UPPER UWCHLAN TOWNSHIP
PLANNING COMMISSION
AGENDA
January 12, 2023

2129 E. High Street | Pottstown, PA 19464
N 40° 14' 40.2" W 075° 36' 09.6"

JOB NO.
137340.01A
SHEET NO.
12 OF 18
DWG. NO.
PC137340-1A

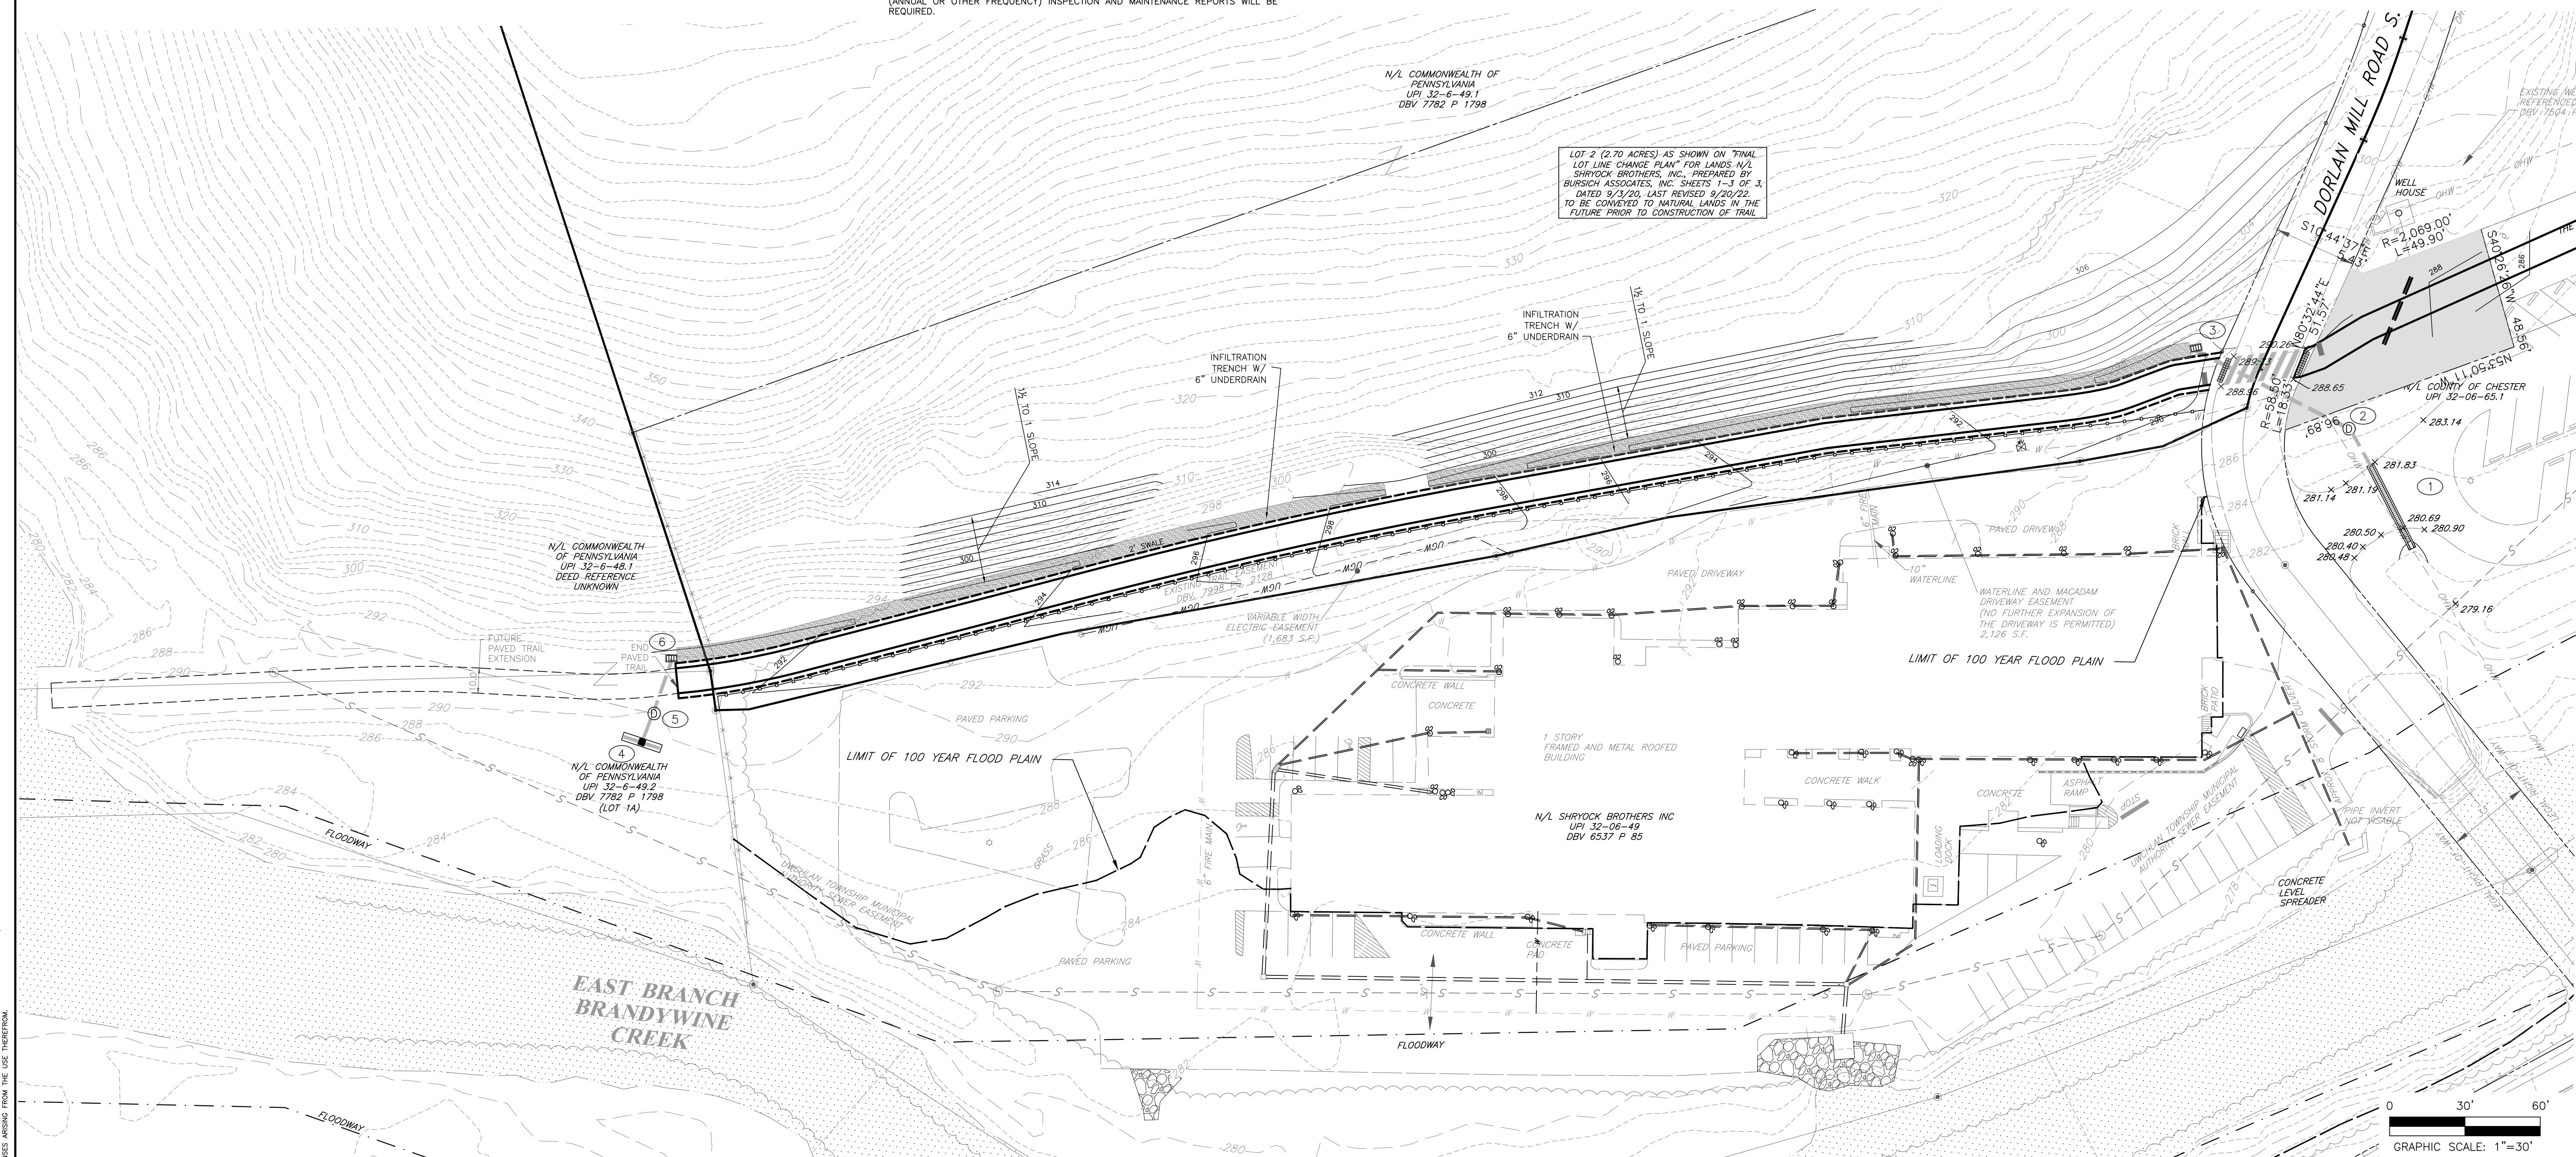
14. Please revise the Inlet 1, MH 2, Trench Drain 3 Profile on Sheet 12 to show a 15" RCP pipe from Inlet 1 to MH 2 as shown in the stormwater report calculations. Also, please revise the graphical image of the Trench Drain in the profile view. It appears to be shown as a 24" pipe.

18. *Please clarify how the existing headwall can be replaced with a Type M inlet (Inlet 5), as the existing 15" CIP pipe appears to flow from the "end of pipe block by boulder" at around elevation 288 towards the headwall invert at 285.96. The profile on Sheet 12 appears to show the existing 15" GIP pipe in the opposite direction.*

Response: The requested statement has been added to the Stormwater Management Site Plan and Operation & Maintenance Plan, Sheet 12 of 18.

Response: The requested statement and signature block has been added to the Stormwater Management Site Plan and Operation & Maintenance Plan, Sheet 12 of 18 to be signed and sealed by the qualified licensed professional responsible for the plan.

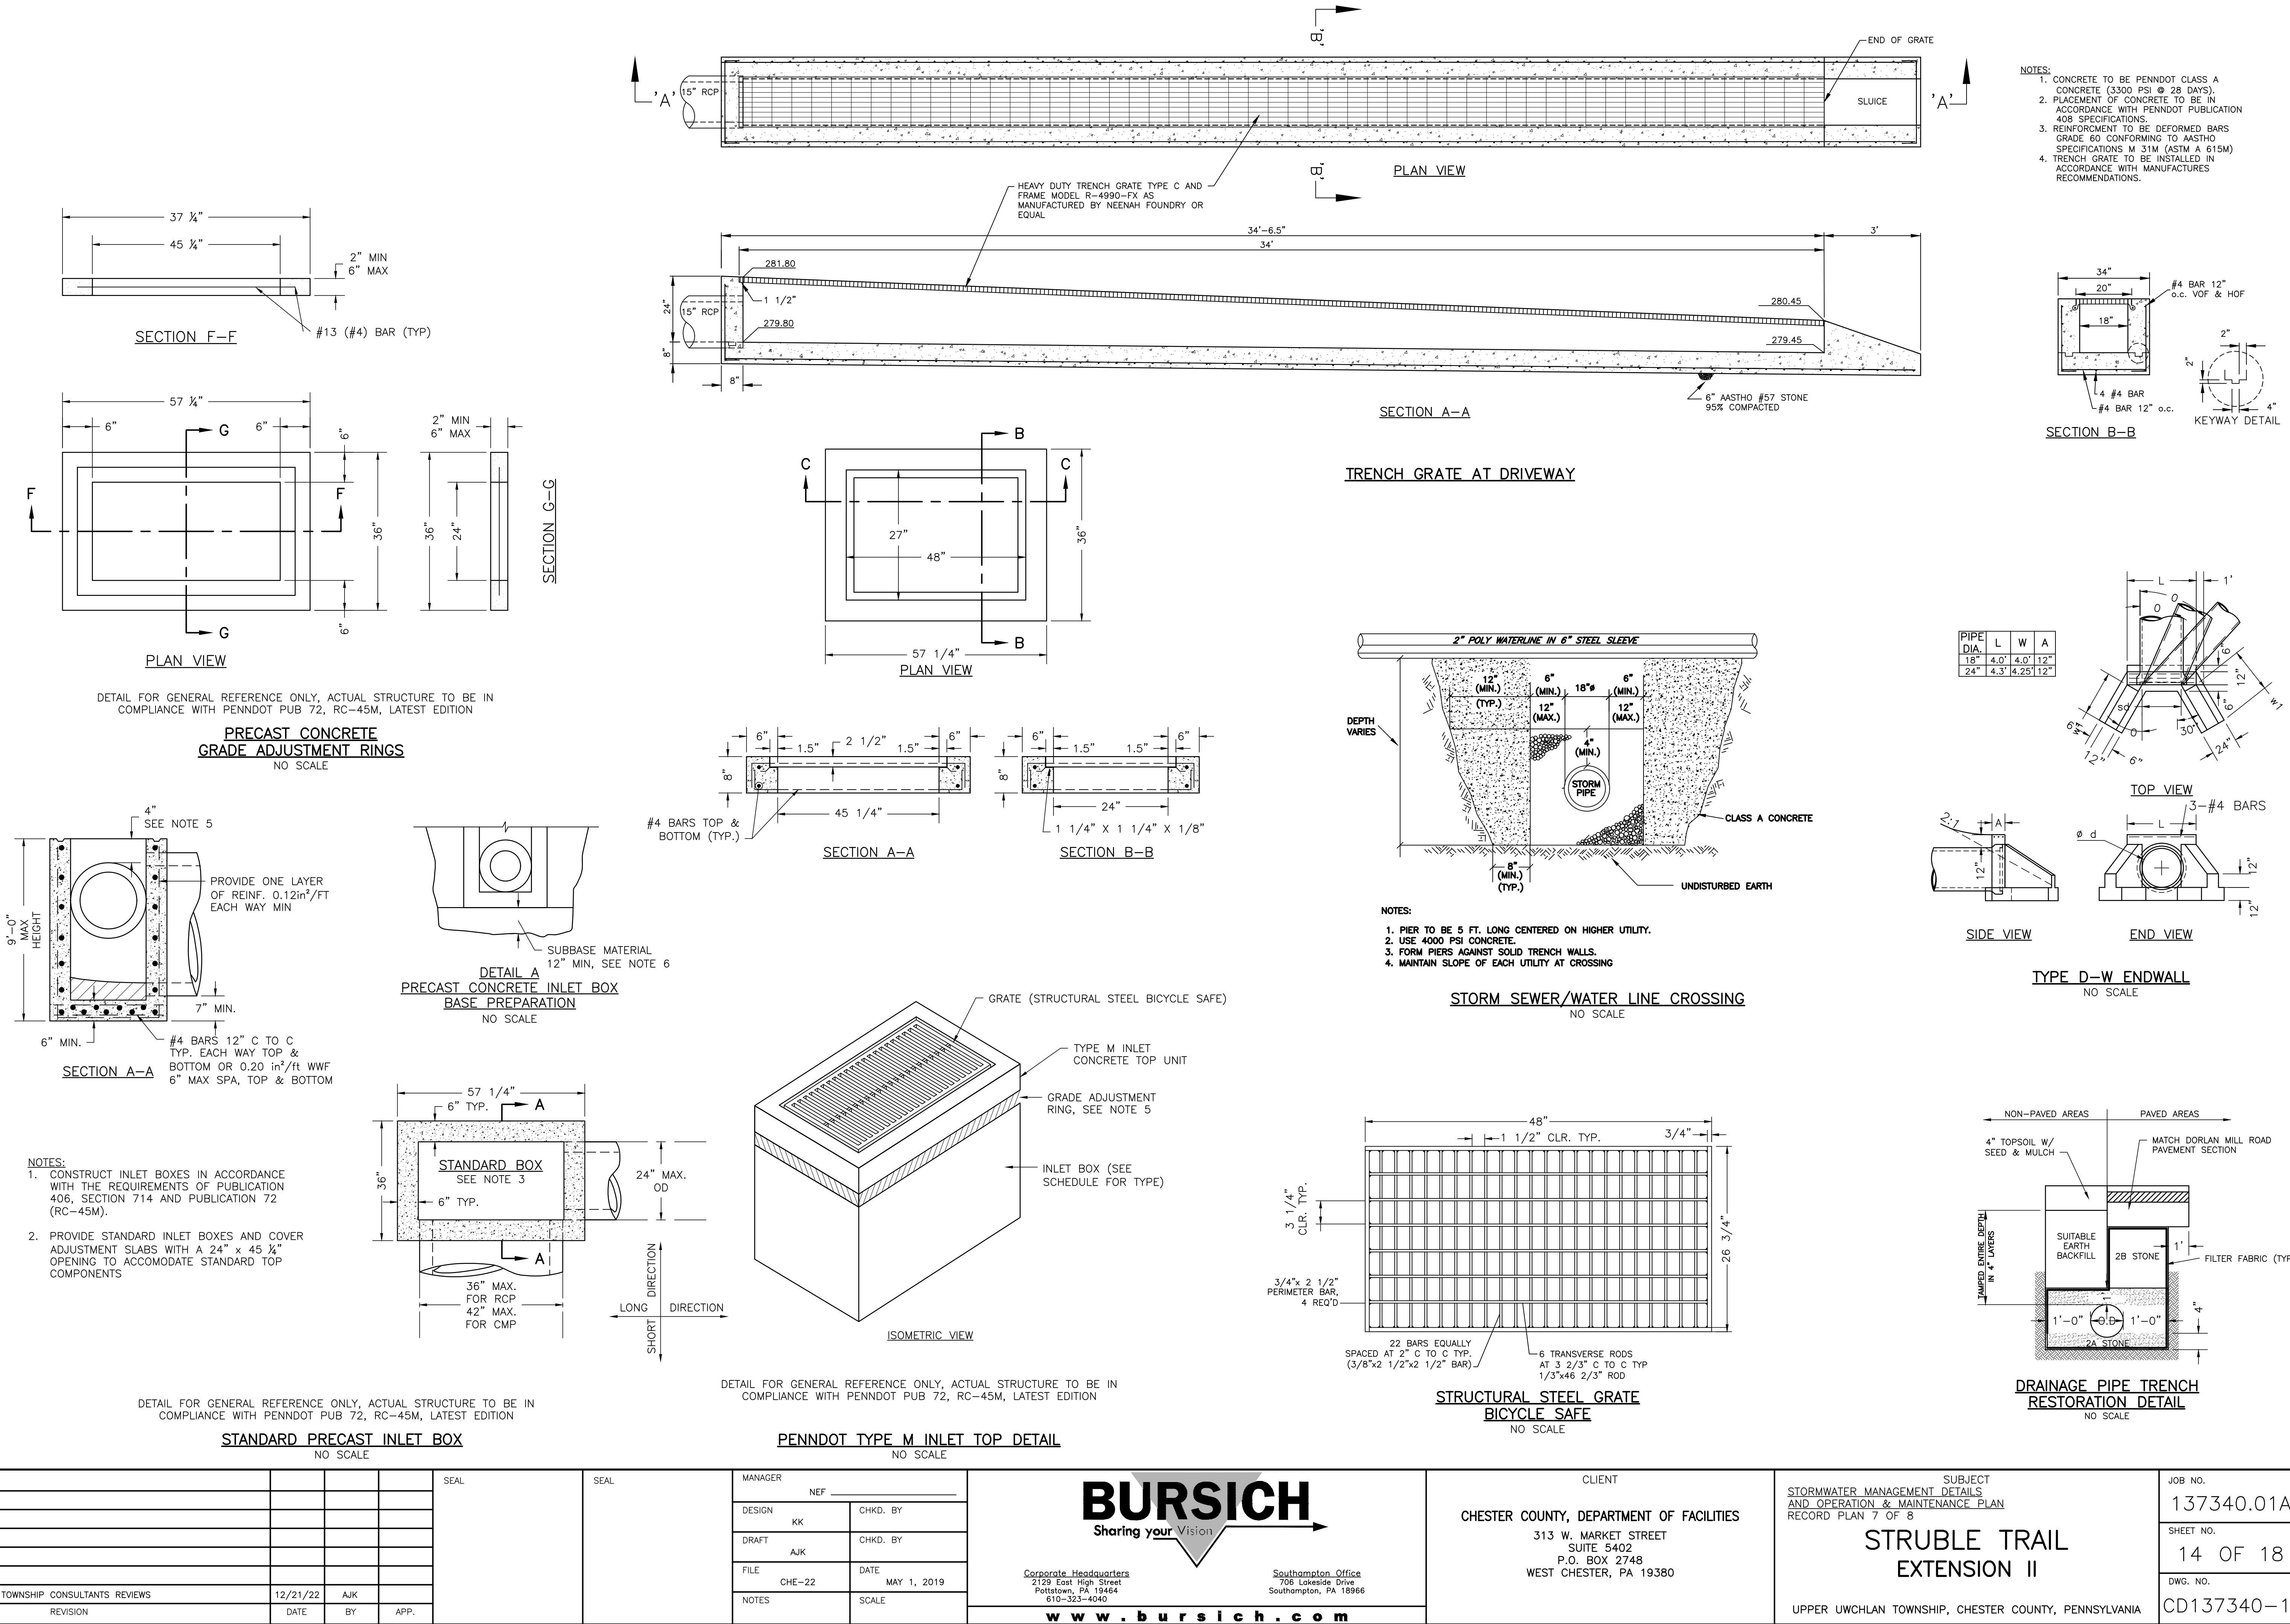
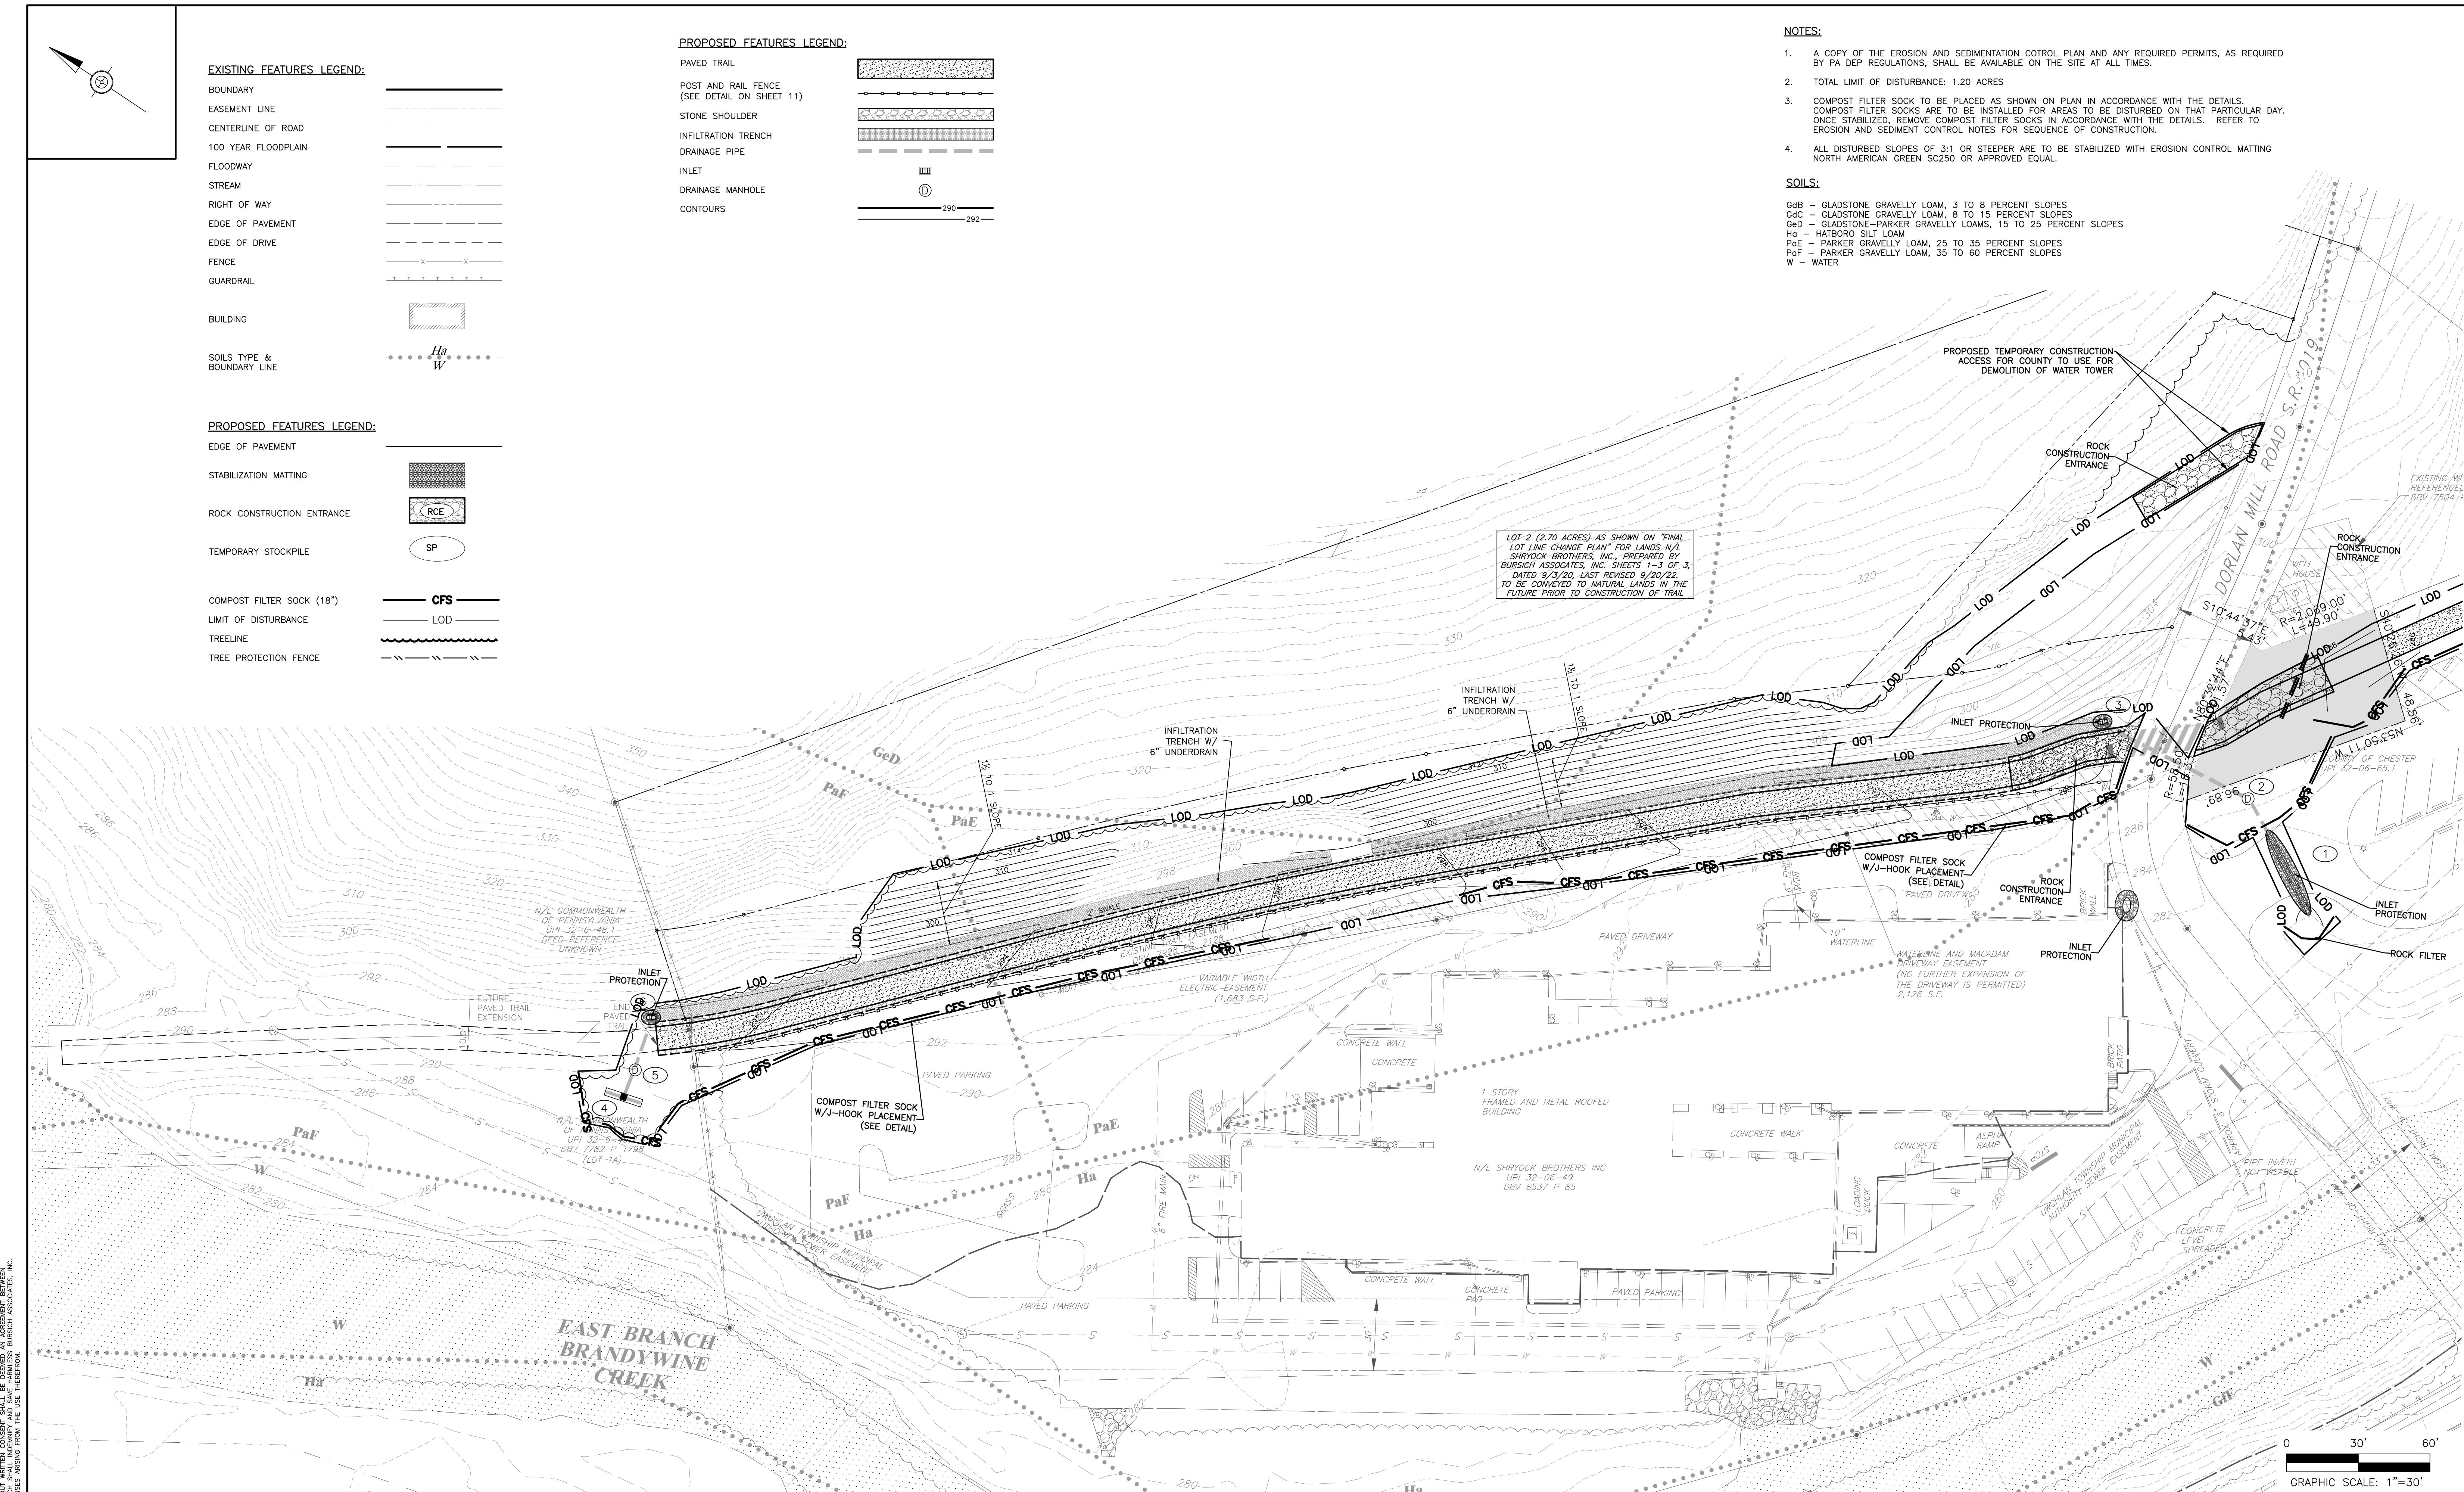
3. §162-9.B.(2)(b)[6] - Please revise the scale on sheets 13 and 14 (Erosion and Sediment Control Plan) to state 1" = 30'. It is currently listed as 1" = 40'.

Response: The scale labels were coordinated (refer to current Sheets 16 & 17).
